VOLUME 2 OF 2 - ZONING

Summary of Comments on P:\Projects\1216-00\BIM\Revit \Families\TITLEBLOCKS\EXTELL Proposal_atwalj.pdf

Summary of Comments on AAI-TWR-ARCHITECTURE-CANTILEVER_namrudl.rvt

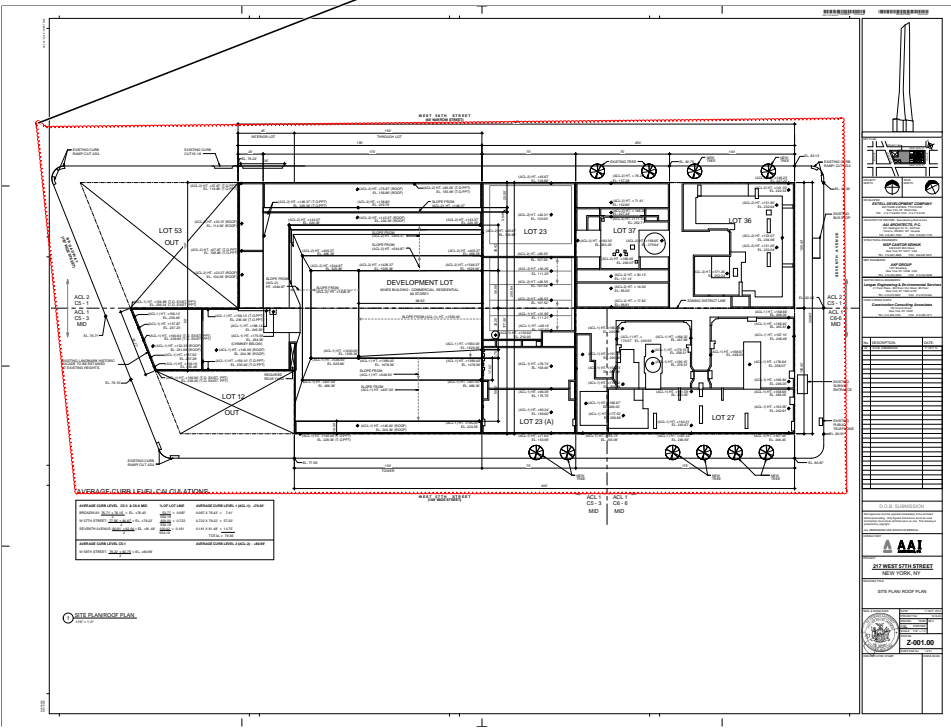
Verify compliance with street tree planting for the entire zoning lot street frontage as per ZR 33-03. Provide ST-1

Provide records to verify proof of existing conditions shown on plans provided, approved drawings of existing building floor area zoning calculation to ensure that the proposed zoning analysis does not exceed the maximum permitted

Verification of existing mechanical deductions is required. Sufficient proof must be provided for entire the deducted floor area. (Dimensions) and provide layout of heavy equipment for each floor in consideration to qualify for deductions.

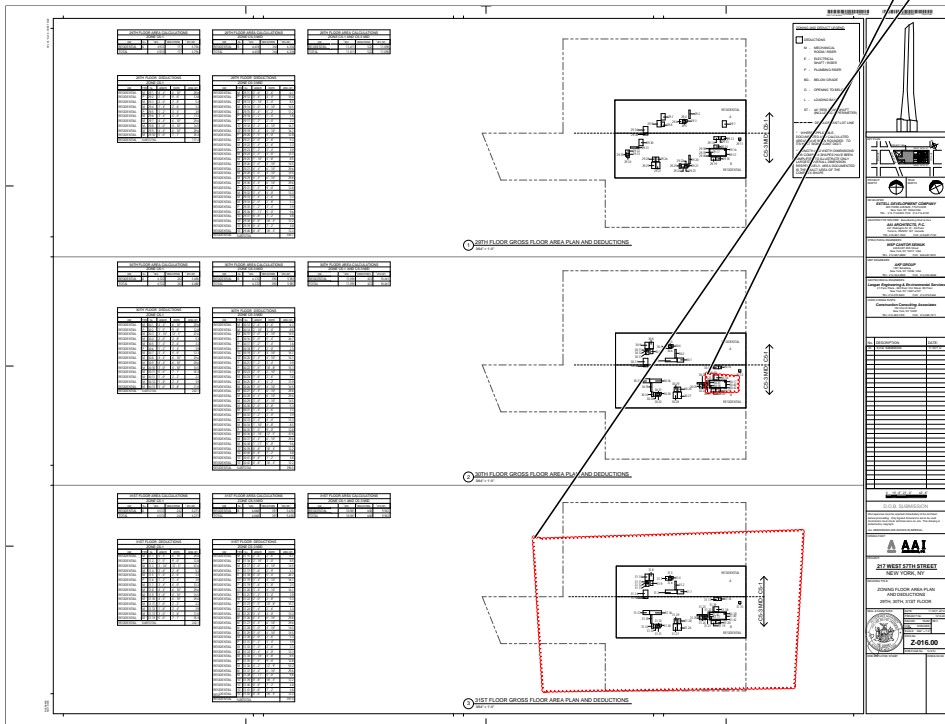
Please clarify deductions taken within stair enclosure. **TYP all floors**
8" for the stair perimeter, not sure what the additional 60+ sq. ft. is for per floor. ARCH/MH dwgs does not indicate any shaft enclosures within stair.

Mech. plan was not provided for this floor. 31st FL.

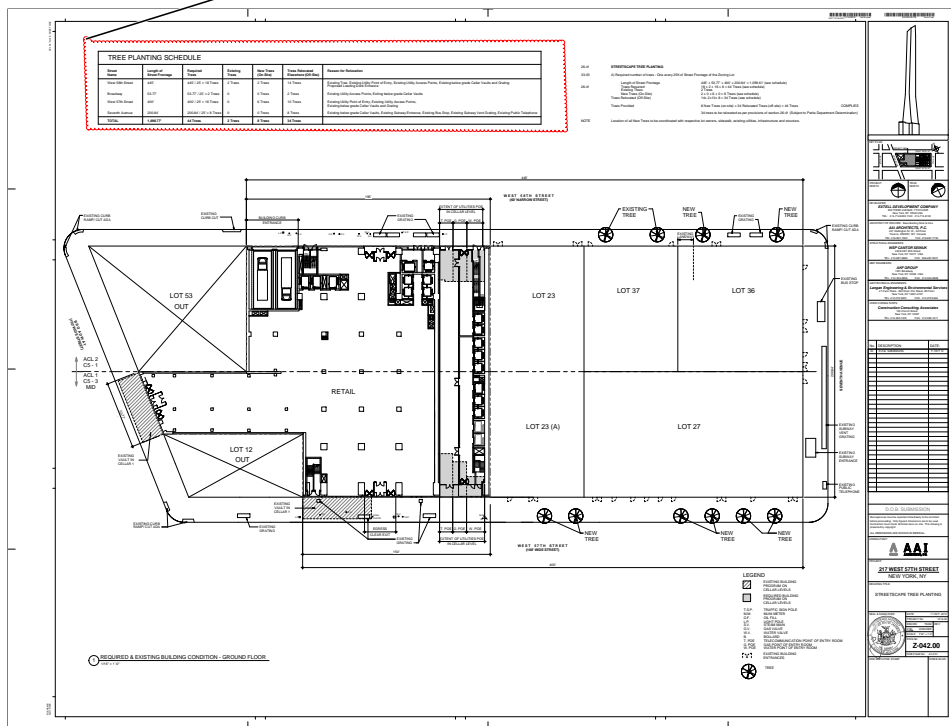
Author: dtitus Subject: Polygon Date: 1/7/2013 9:14:54 AM
Compliance with Appendix G – flood hazard zone requirements. **Flood zone:** verify in zoning analysis (provide FEMA map) and state that building is not in flood zone. If in flood zone, habitable space must be above the elevation of the flood plain and other space below flood elevation must be flood proofed. Also, provide note on sch. regarding flood zone in accordance with Appendix G (Feb. 20, 2004). (provide map on dwg. to verify compliance) 04-03-13

BC 1801
BC 1805 Verify and provide compliance for foundation plans. 04-03-13

Provide structural dwg's. Provide structural, foundation, excavation and earthwork plans (BC 106.7, BC 106.8). 04-03-13

TR-1 for underpinning, sheeting and shoring with details as per BC 1704.9.1 & 1704.19 04-16-13

Provide note: notification to DOB 24-48 hours prior to commencement of earthwork as per BC 3304.3.1. 04-03-13

BC 104
BC 1701 TR-1 for special /controlled/progress inspections: a) concrete, b) concrete test pits & c) concrete test cylinders

Comply with TPPN 10/88 to avoid damage to historic landmark structures adjacent building (check all buildings within a 98' radius to find out if compliance is needed). Indicate on drawings to verify if compliance with TPPN 10/88 is needed. 04-16-13

BC F101 Rodent –proofing; indicate compliance with rodent –proofing requirements for design and construction 04-03-13

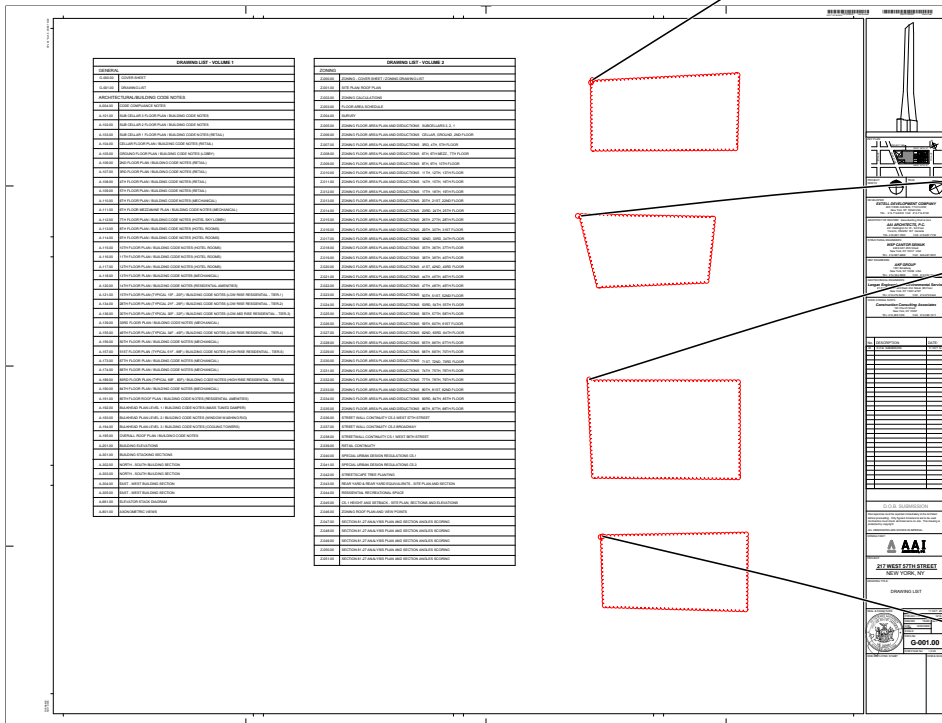
Supporting documentation: heating and cooling systems, including controls, are not provided such that they match the systems, equipment and performance criteria in the energy analysis.

Supporting documentation: plans fail to include reflected ceiling plans or lighting layouts on floor plans with fixture types and quantities, lamp wattages and quantities, space areas, sensors and controls to match those in the energy analysis for each room in the building.

Supporting Documentation: Building wall sections fail to label insulation at the roof/ceiling, wall and/or at the foundation, slab-on grade, basement or cellar with R values matching those in the Energy Analysis.

Indicate on drawings fire ratings for all proposed partitions /interior sections and details for verification purposes construction. Indicate construction materials and fire rating of construction elements of building to verify compliance with requirements of Table 601 class I-B structure.

File separate applications for and indicate on plans;
 Sprinkler, 903 BC
 Standpipe, 905BC
 Fire alarm,
 Site safety plan - article 110
 Fire protection plan - article 109
 Curb cut.
 Emergency power systems (Generators)

Building containing more than one occupancy group shall comply with sections BC 508.3.1, 508.3.2, 508.3.3 or a combination of these sections.

Verify compliance with MDL and HMC. 04-03-13

Identify required control inspections (28-104.7). 04-03-13

BC 903.2.10 Trash compactor is required for building which contains more than 12 units.

- Indicate trash compactor size, dimensions, & location.
- indicate clearance around trash compactor
 - Indicate sprinkler locations in the trash compactor room.
 - indicate ventilation to fresh air at trash compactor room
 - provide floor drain at trash compactor room
 - Indicate a minimum, 3 hr fire rated enclosure (walls) at trash compactor room i, including 1 1/2hr FPSC rated door.
 - indicate construction details and materials at trash compactor room
 - Indicate sound transmission class (stc) ratings for all trash compactor walls and trash chute walls and disposal; room walls.

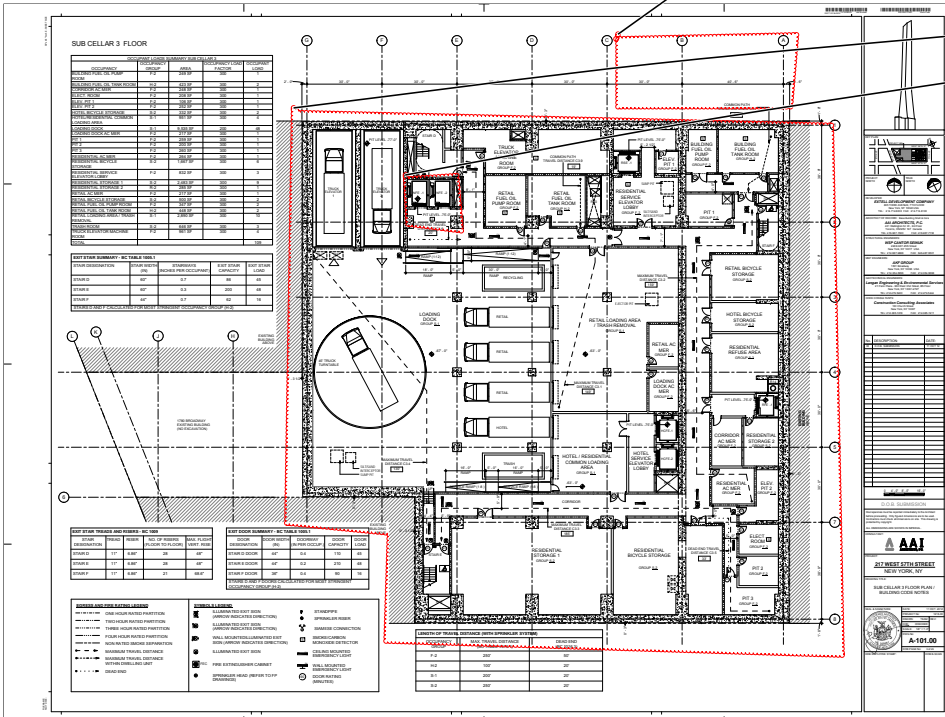
Author: dtitus Subject: Polygon Date: 1/7/2013 10:09:39 AM
Verify compliance for underground building as per BC 405

Author: dtitus Subject: Polygon Date: 1/7/2013 10:11:28 AM
BC 405.4.3 Elevators. Verify compliance.

Author: dttus Subject: Polygon Date: 1/7/2013 10:15:09 AM
TABLE 403.1 Provide table for plumbing fixtures to comply with table 403.1. Provide calculations within each space, etc. and show layout to verify compliance to BC 1101.2; ICC/ANSI A117.1-2003

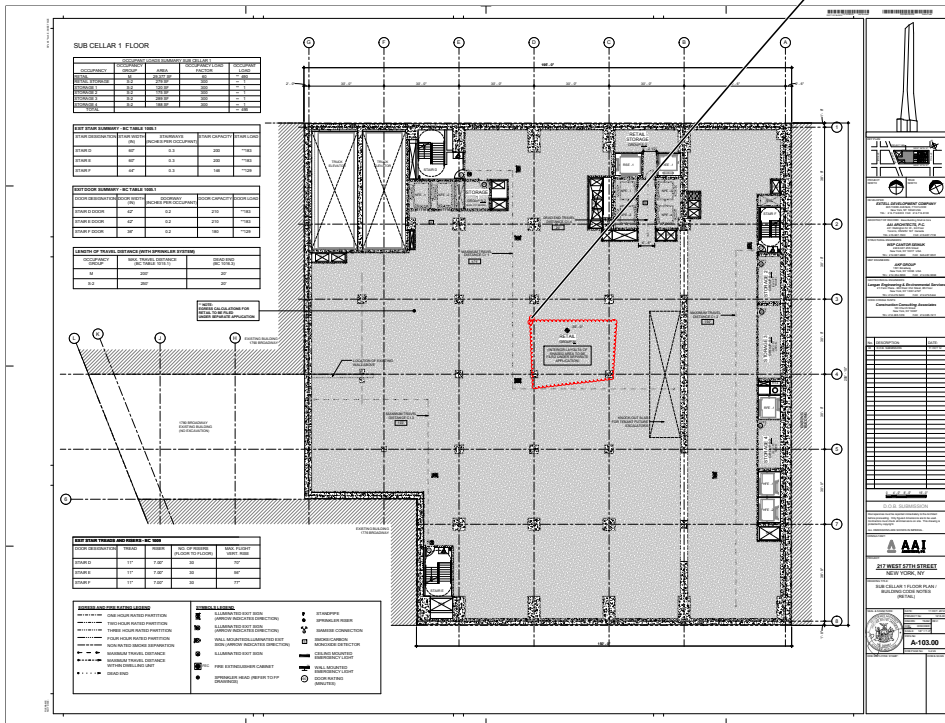
All nonresidential facilities to comply with BC 1109.

Water closets

Lavatories
Show all

Show all grab-bars including vertical

Required clearance around the water closet to comply with ICC/ANSI 2003 604.3

TABLE 403.1 Provide table for plumbing fixtures to comply with table. 403.1. Provide calculations within each space, etc. and show layout to verify compliance to BC 1101.2; ICC/ANSI A117.1-2003

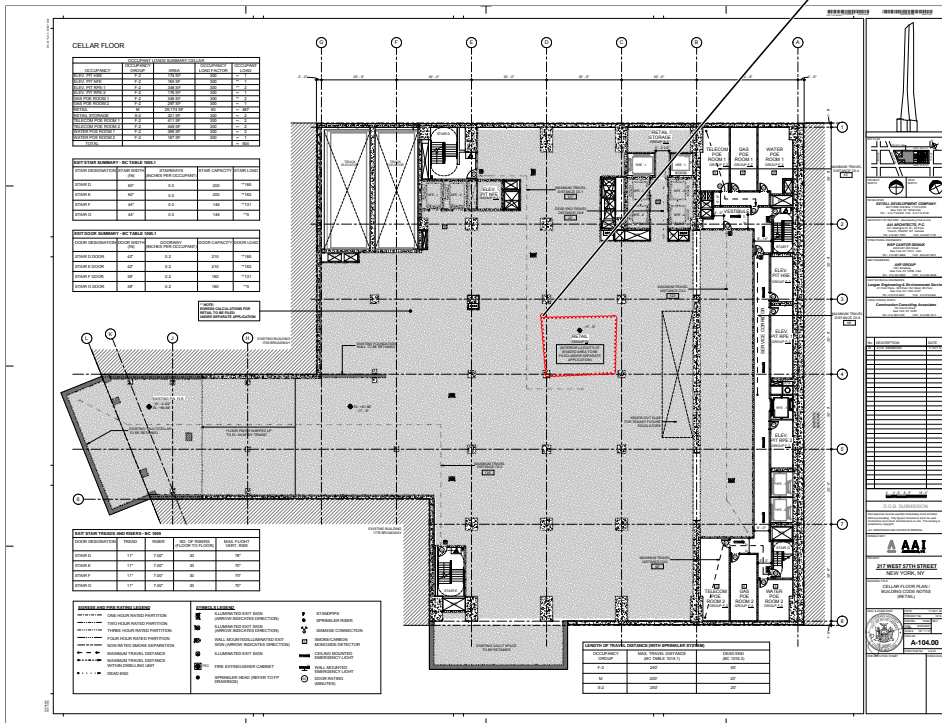
All nonresidential facilities to comply with BC 1109.

Water closets

Lavatories

Show all grab-bars including vertical

Required clearance around the water closet ~~to~~ comply with ICC/ANSI 2003 604.3

Author: dtitus Subject: Polygon Date: 1/2/2013 12:52:48 PM
Provide curb cut details with plans and sections. **04-03-13**

open Location of proposed curb cut is contrary to section BC 406.7.6 (3). This is not a corner lot and a minimum separation of 8'-0" is required from side lot line.

Author: dtitus Subject: Polygon Date: 1/7/2013 10:14:43 AM
TABLE 403.1 Provide table for plumbing fixtures to comply with table 403.1. Provide calculations within each space, etc. and show layout to verify compliance to BC 1101.2; ICC/ANSI A117.1-2003 **04-03-13**

All nonresidential facilities to comply with BC 1109.
Water closets
Lavatories
Show all grab-bars including vertical
Required clearance around the water closet to comply with ICC/ANSI 2003 604.3 **04-03-13**

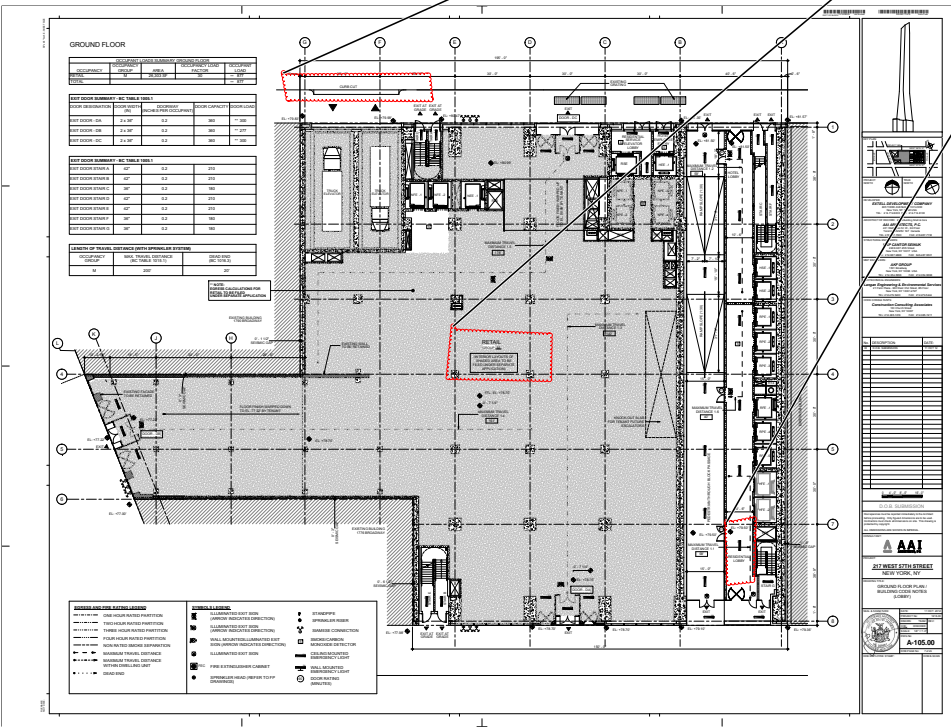
Author: dtitus Subject: Polygon Date: 1/2/2013 12:56:20 PM
Provide note to verify compliance with BC 1008.4.1; 1008.4.2; 1008.4.3; 1008.4.4 **04-16-13**

BC 1910, LL 17/95 **Earthquake**
state on plan and show compliance with LL 17/95;
separation (1" per 50 ft. height); (compliance must be verified on A & ST floor plans)
earthquake code applicability & pounding notes;

Author: dtitus Subject: Polygon Date: 1/7/2013 9:28:30 AM
Elevator to accommodate 24"x76" ambulance stretcher (BC 3002.4).

TABLE 403.1 Provide table for plumbing fixtures to comply with table. 403.1. Provide calculations within each space, etc. and show layout to verify compliance to BC 1101.2; ICC/ANSI A117.1-2003

All nonresidential facilities to comply with BC 1109.
Water closets
Lavatories
Show all grab-bars including vertical
Required clearance around the water closet to comply with ICC/ANSI 2003 604.3

Provide exit lighting and directional signs (lighting) & (egress) as per BC 1006, BC 1011, BC 1026 (both EG and Construction plans)

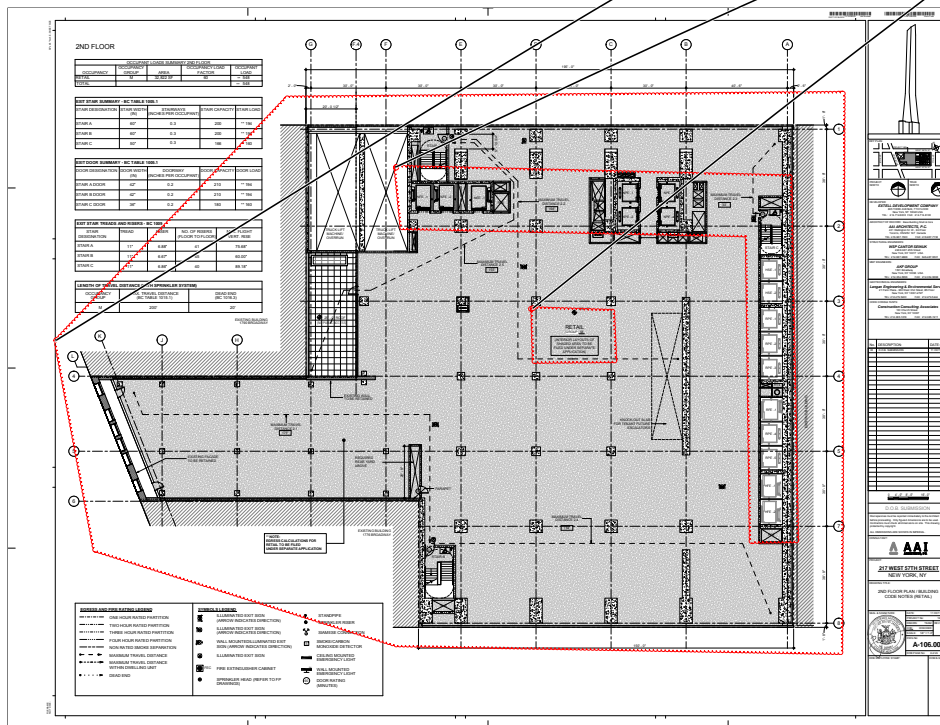
TABLE 403.1 Provide table for plumbing fixtures to comply with table. 403.1. Provide calculations within each space, etc. and show layout to verify compliance to BC 1101.2; ICC/ANSI A117.1-2003

All nonresidential facilities to comply with BC 1109.

Water closets

Lavatories

Show all grab-bars including vertical

Required clearance around the water closet to comply with ICC/ANSI 2003 604.3

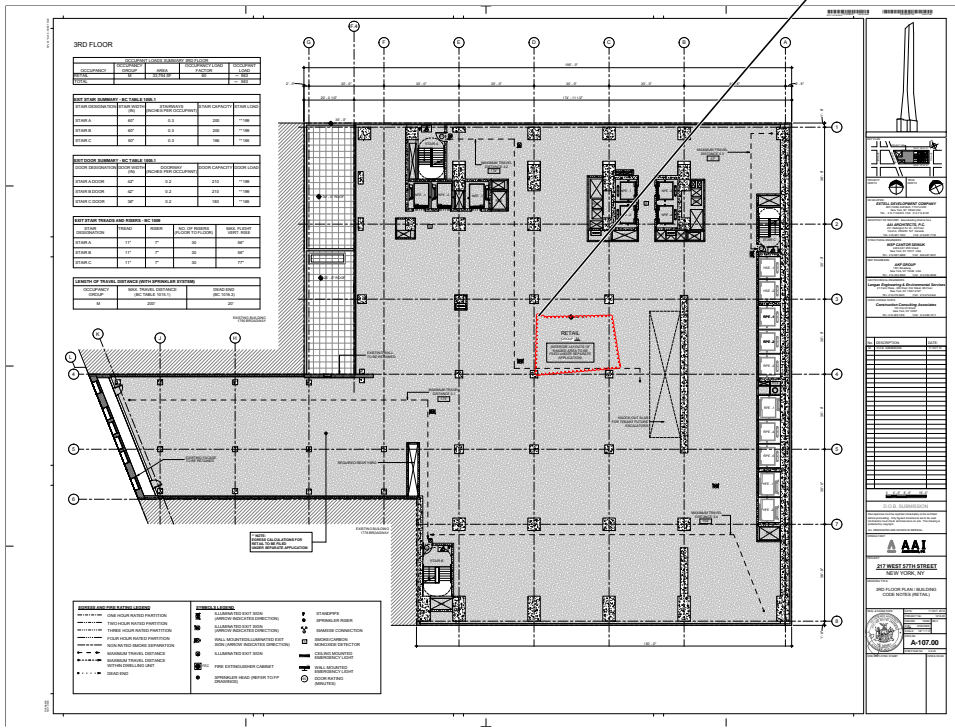
TABLE 403.1 Provide table for plumbing fixtures to comply with table 403.1. Provide calculations within each space, etc. and show layout to verify compliance to BC 1101.2; ICC/ANSI A117.1-2003

All nonresidential facilities to comply with BC 1109.

Water closets

Lavatories

Show all grab-bars including vertical

Required clearance around the water closet to comply with ICC/ANSI 2003 604.3

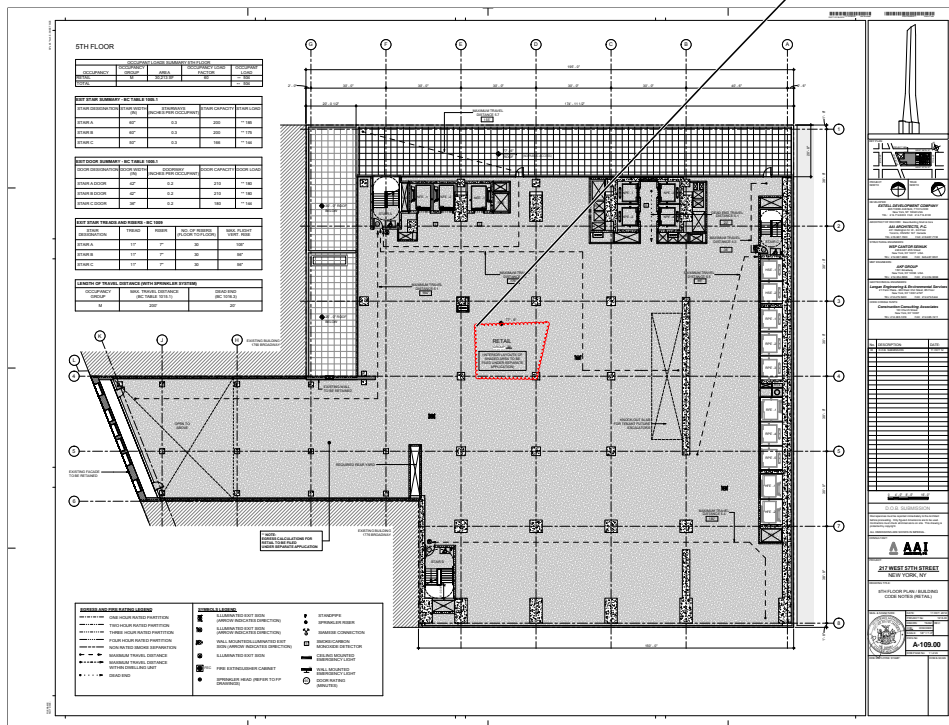
All nonresidential facilities to comply with BC 1109.

Water closets

Lavatories
Chow hall

Show all grab-bars including vertical

Required clearance around the water closet to comply with ICC/ANSI 2003 604.3

Author: dtitus Subject: Polygon Date: 1/7/2013 9:34:02 AM
TABLE 403.1 Provide table for plumbing fixtures to comply with table. 403.1. Provide calculations within each space, etc. and show layout to verify compliance to BC 1101.2; ICC/ANSI A117.1-2003

All nonresidential facilities to comply with BC 1109.
Water closets
Lavatories
Show all grab-bars including vertical
Required clearance around the water closet to comply with ICC/ANSI 2003 604.3

Provide exit lighting and directional signs (lighting) & (egress) as per BC 1006, BC 1011, BC 1026 (both EG and Construction plans) 04-16-13

Author: dtitus Subject: Polygon Date: 1/7/2013 8:48:05 AM
BC 903.2.12.2 Commercial cooking operations. An automatic sprinkler system shall not be installed in a commercial kitchen exhaust hood and duct system. Fire extinguishing systems shall be installed in commercial cooking systems in accordance with Section 904.11.

BC 904.2.1 Hood system suppression. Each required commercial kitchen exhaust hood and duct system required by the *New York City Fire Code* or the *New York City Mechanical Code* to have a Type I hood shall be protected with an approved automatic fire-extinguishing system installed in accordance with this code.

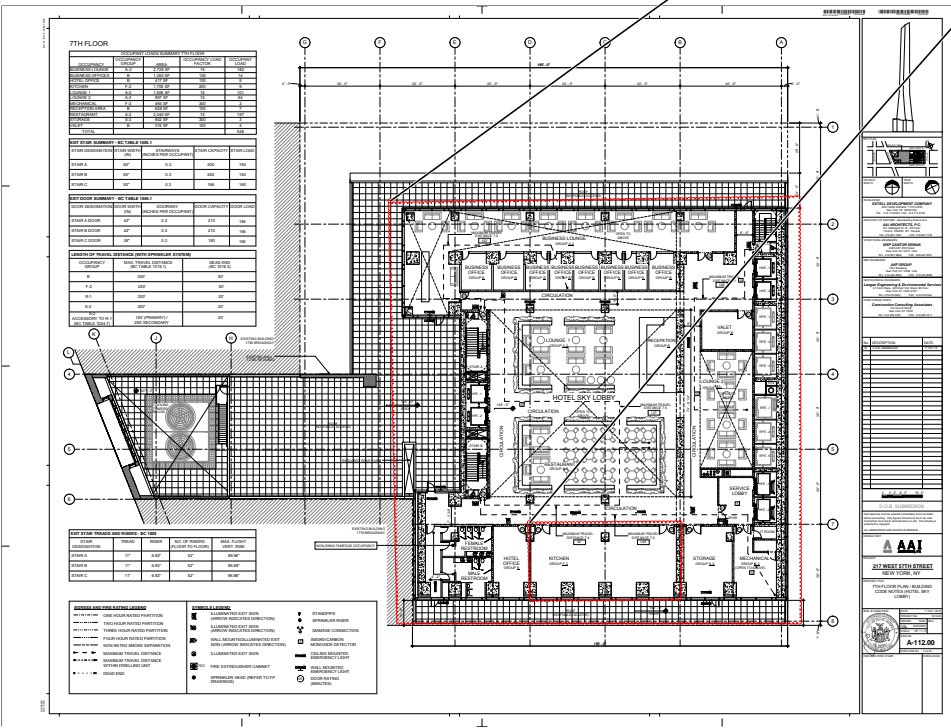
Kitchen shall also comply with MC 506, 507, and 508; PC 802.1.7 and 1003.3.1. Please verify on MH/PL plans.

Provide note describing stairway door operation and stairway communications system as per BC 403.12

Provide note describing smoke proof exit enclosures for compliance with BC 403.13. 04-16-13

Provide note describing impact-resistant stairs enclosures as per BC 403.15 04-16-13

Indicate photo luminescent exit path markings as per BC 403.16. 04-16-13

Provide exit lighting and directional signs (lighting) & (egress) as per BC 1006, BC 1011, BC 1026 (b)
